**CITY OF NEW CUMBERLAND
HANCOCK COUNTY, WEST VIRGINIA**

**CONTRACT #2 – CUMBERLAND HEIGHTS WATER STORAGE TANK
REPLACEMENT & REHABILITATION AND SUNSET LANE WATER STORAGE**

ADDENDUM # 1

**January 15, 2021
THRASHER PROJECT NO. 101-010-1041**

CITY OF NEW CUMBERLAND
CUMBERLAND HEIGHTS WATER STORAGE TANK
REPLACEMENT & REHABILITATION
AND SUNSET LANE WATER STORAGE TANKS
ACCESS ROAD PROFILE & DETAILS

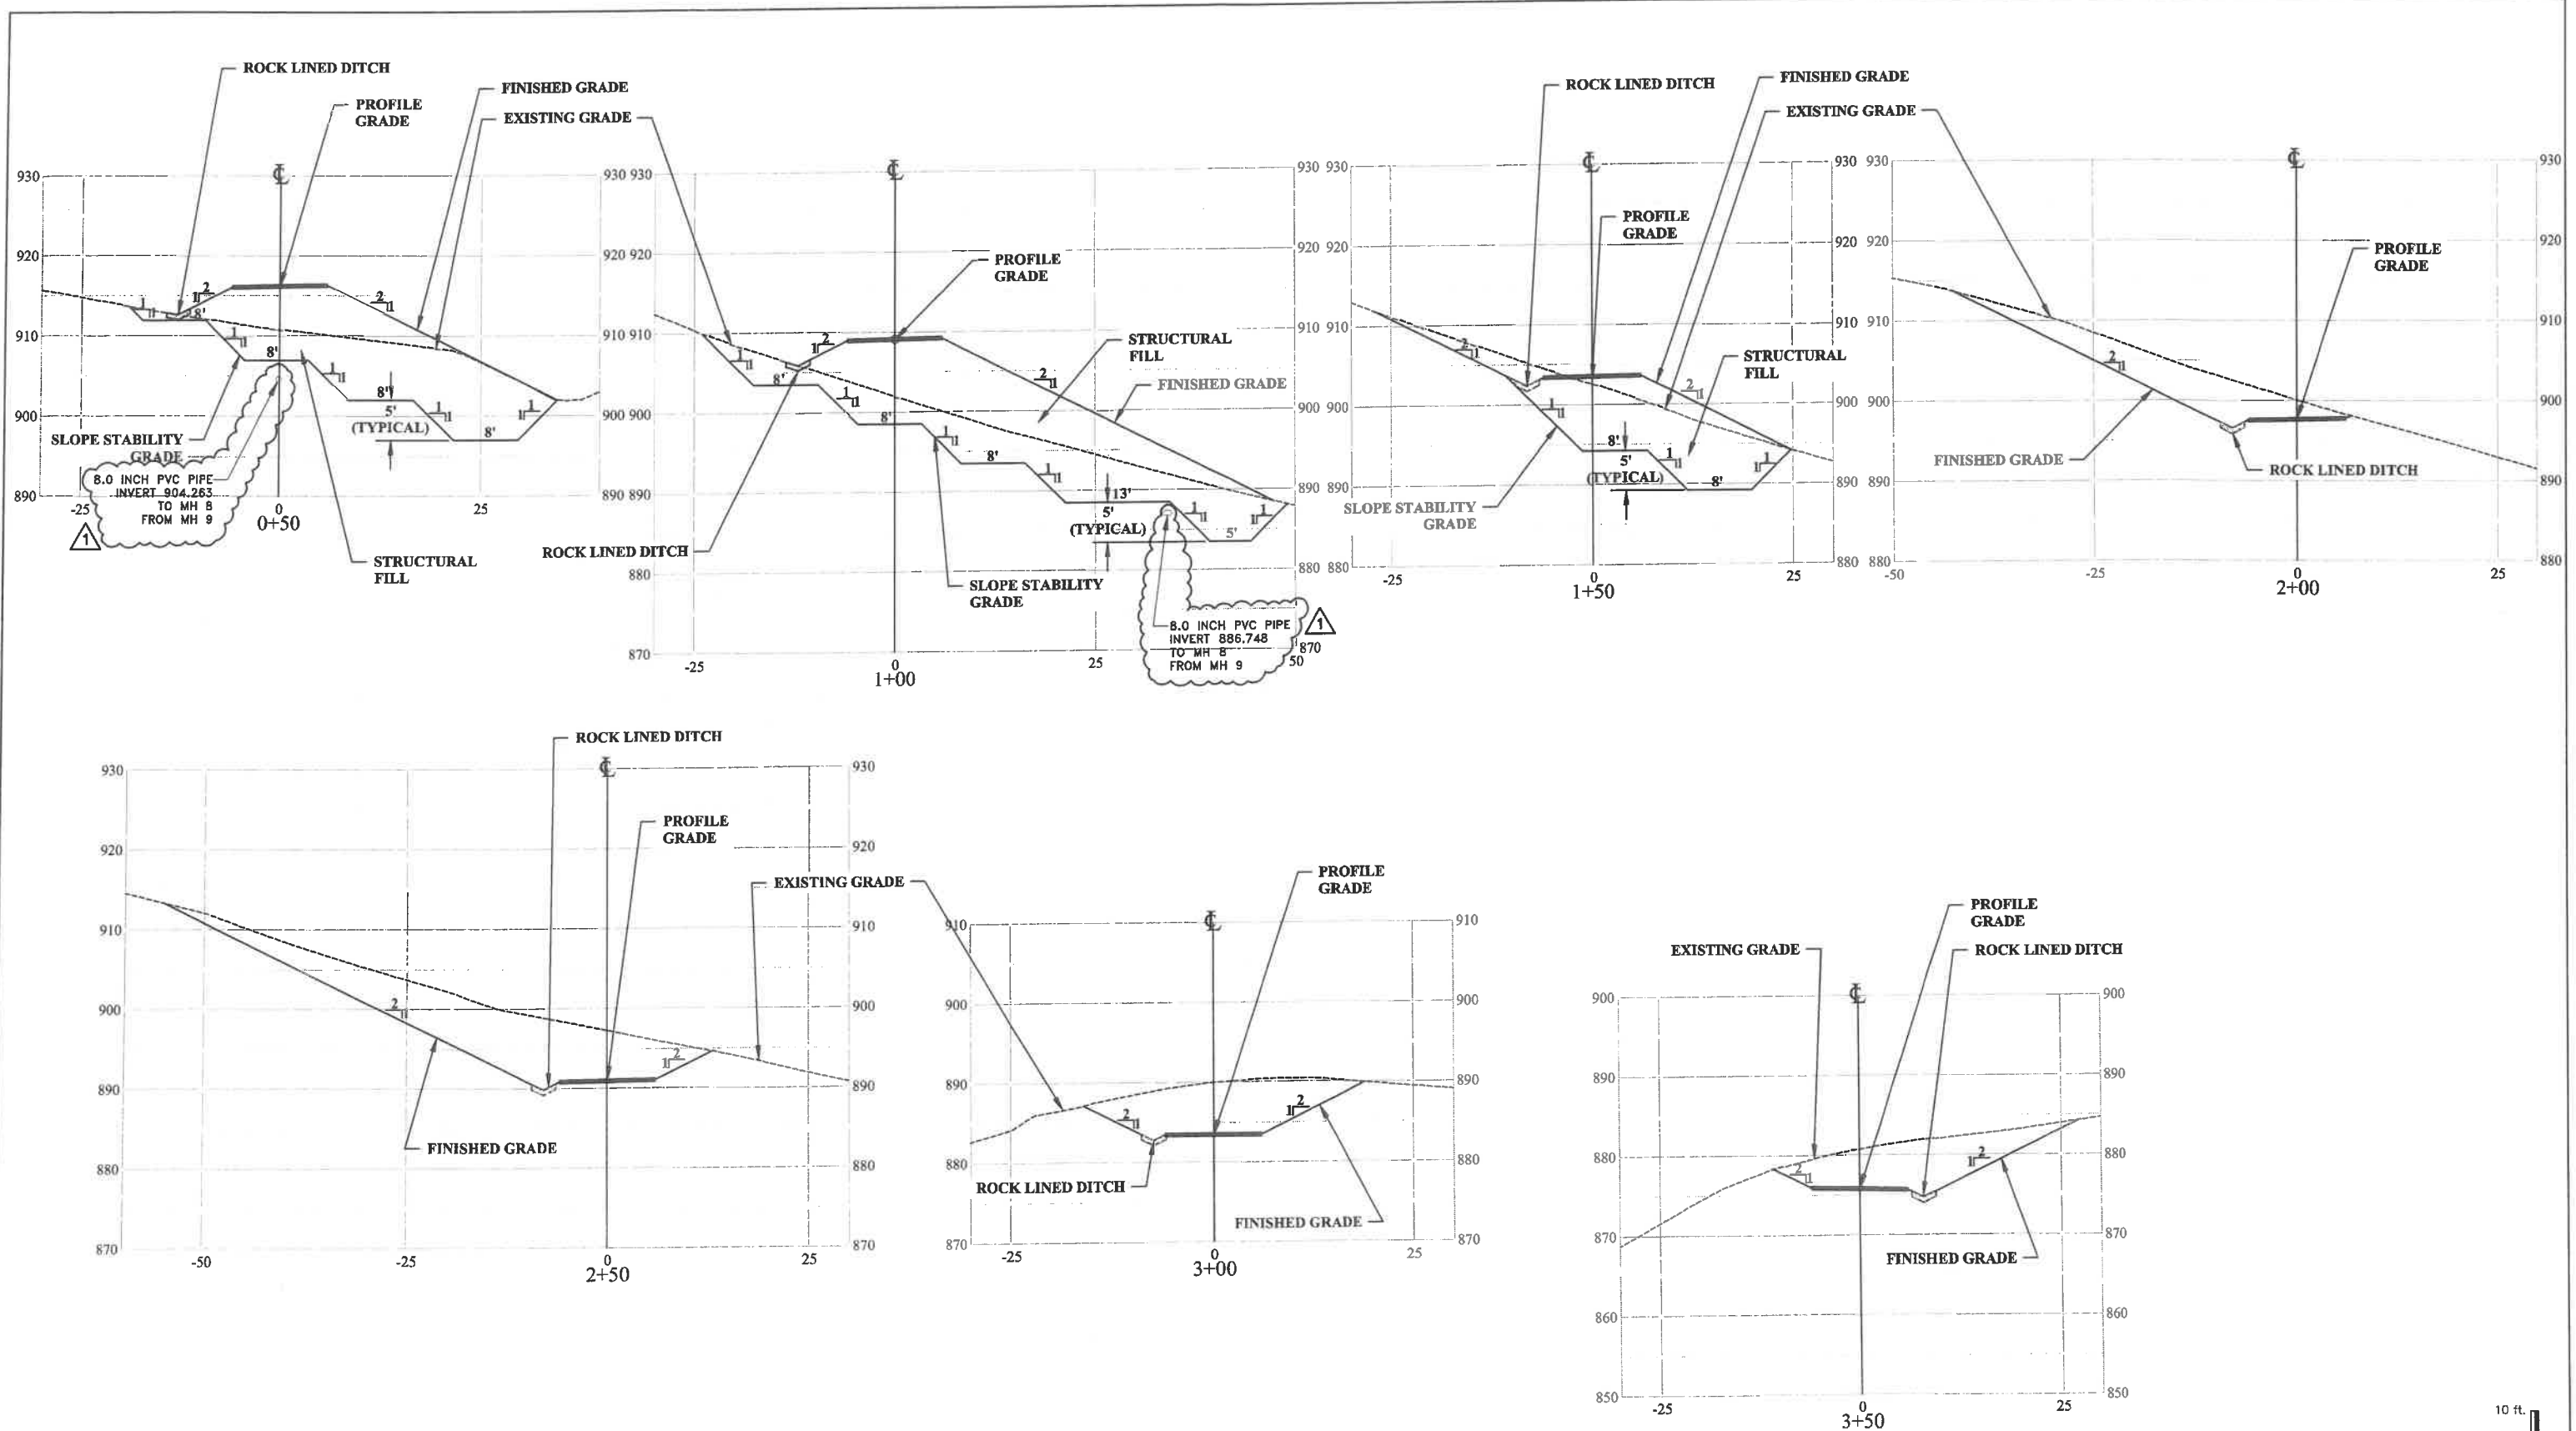
NO.	BY	DATE	DESCRIPTION
1	AN	1/11/21	ADDED EXISTING SEWER

CITY OF NEW CUMBERLAND
CUMBERLAND HEIGHTS WATER STORAGE TANK
REPLACEMENT & REHABILITATION
AND SUNSET LANE WATER STORAGE TANKS
ACCESS ROAD SECTIONS

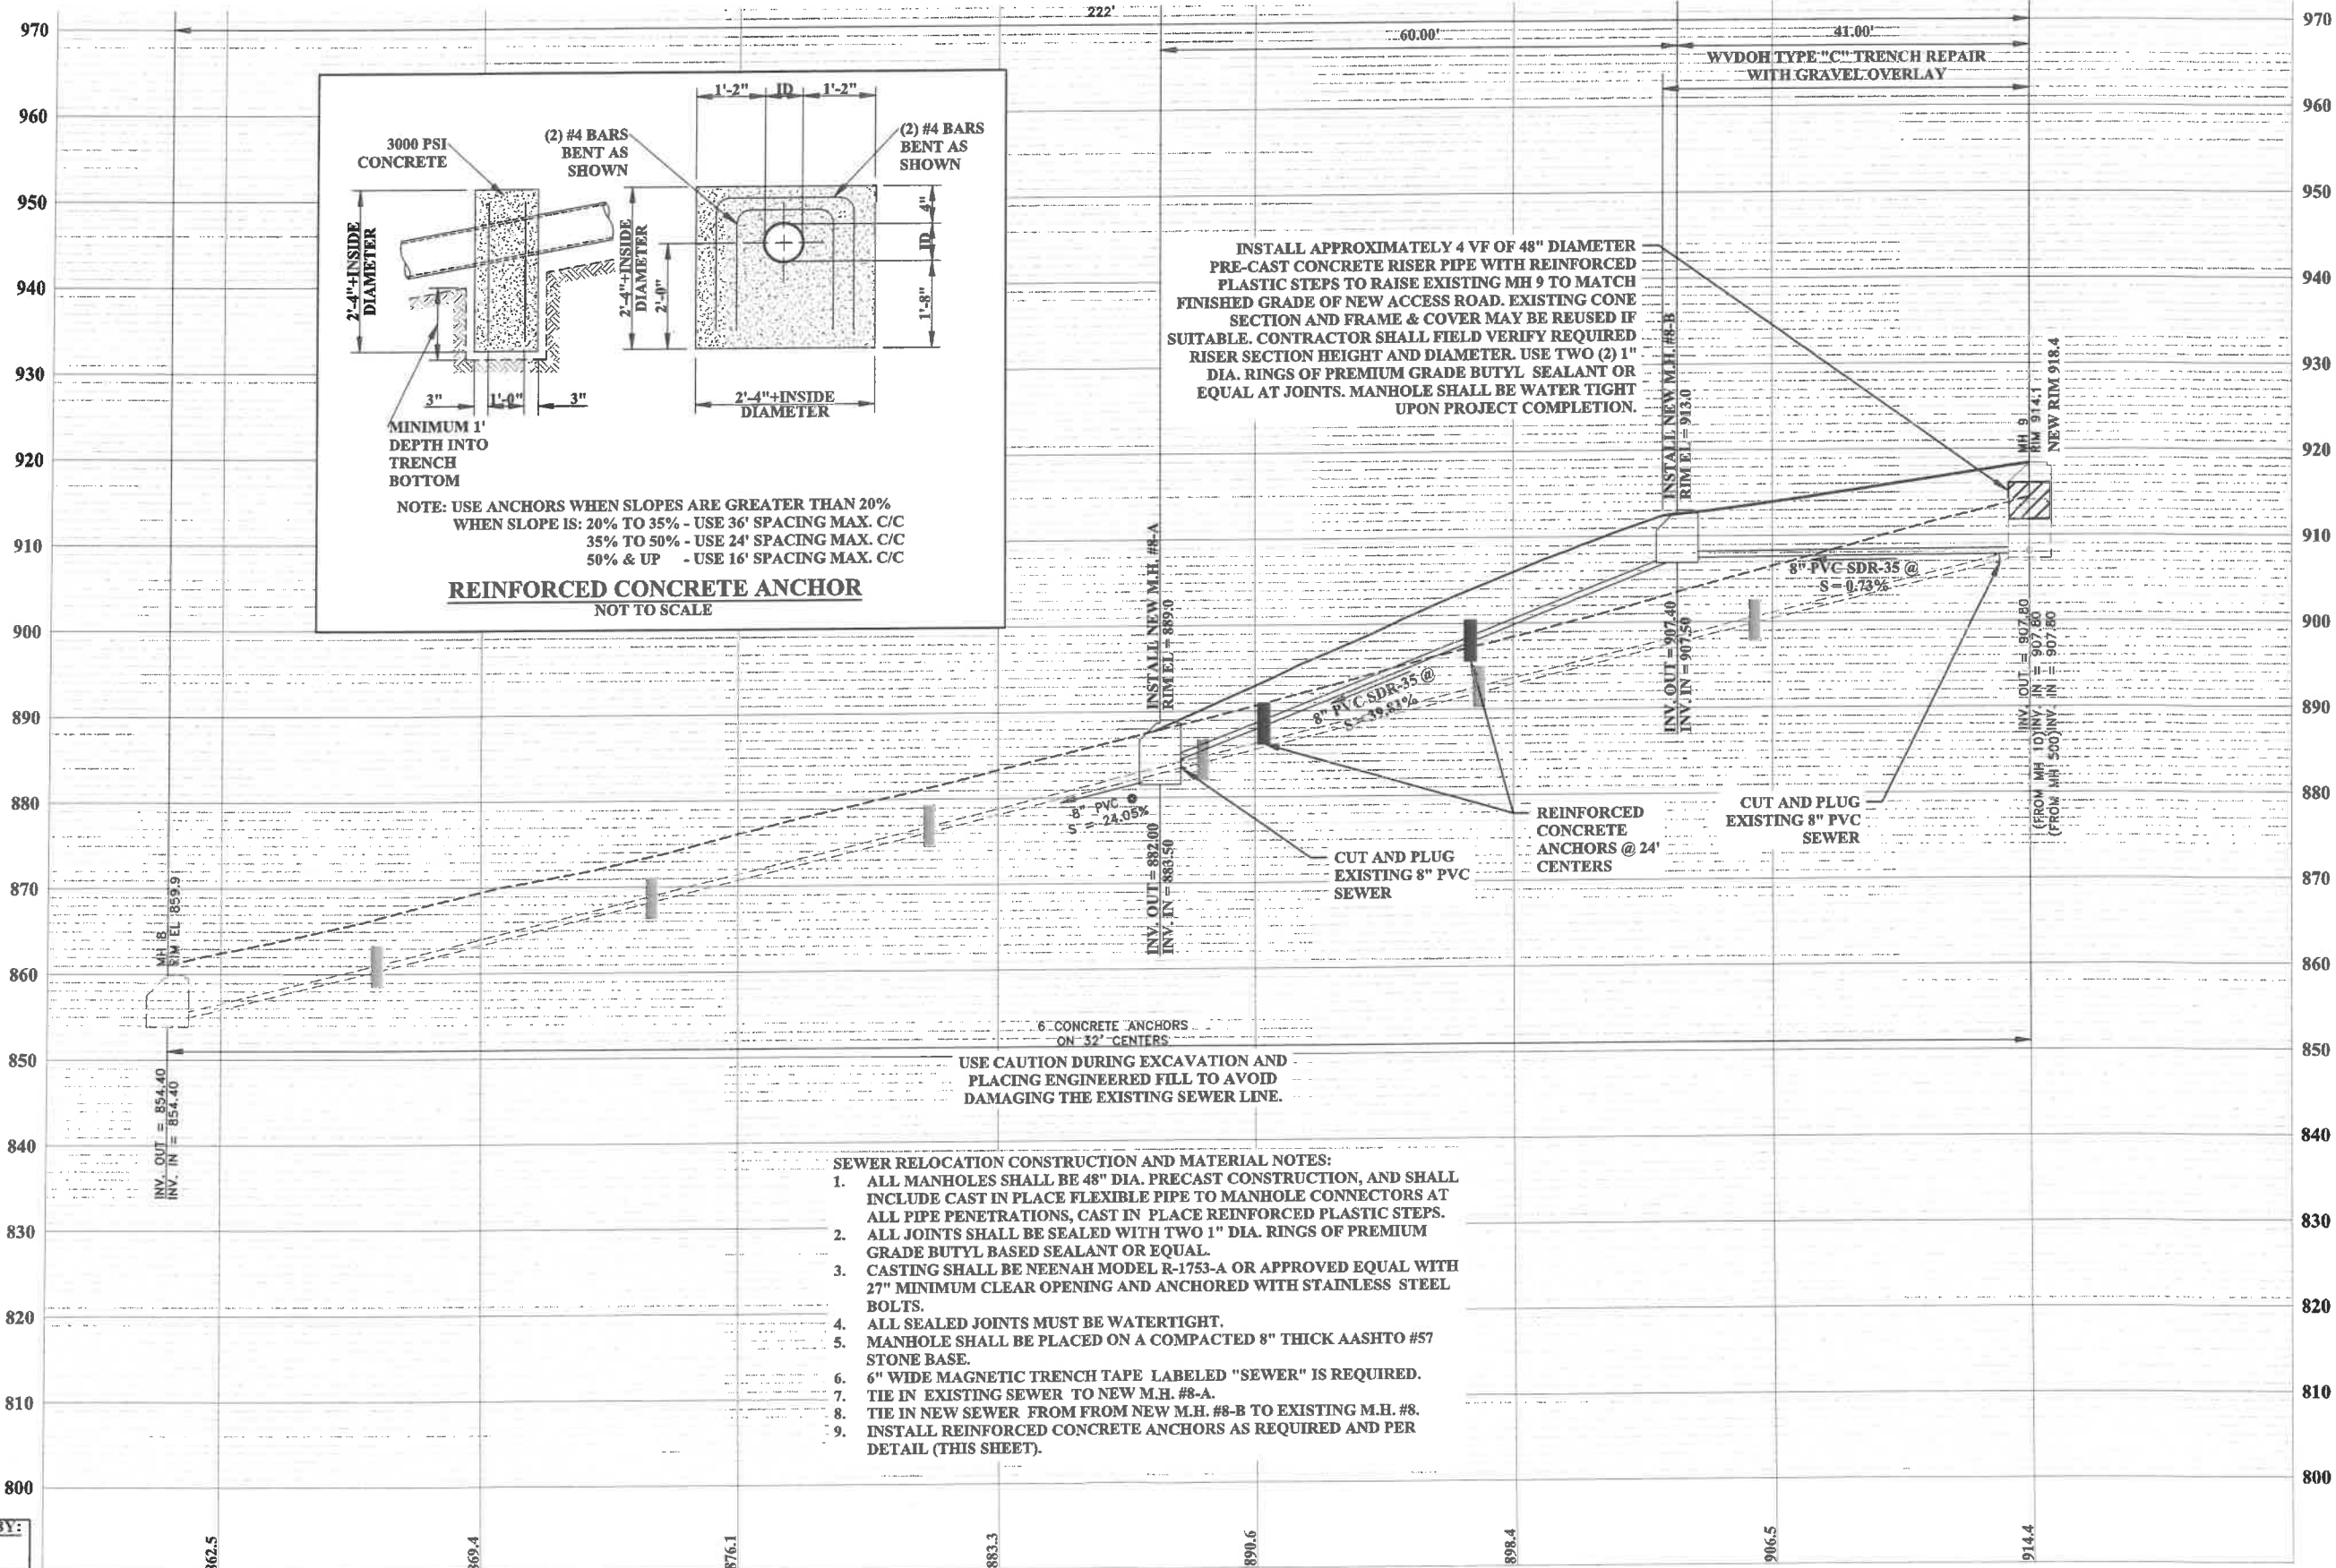
NO.	BY	DATE	DESCRIPTION
1	AN	1/11/20	ADDED EXISTING SEWER
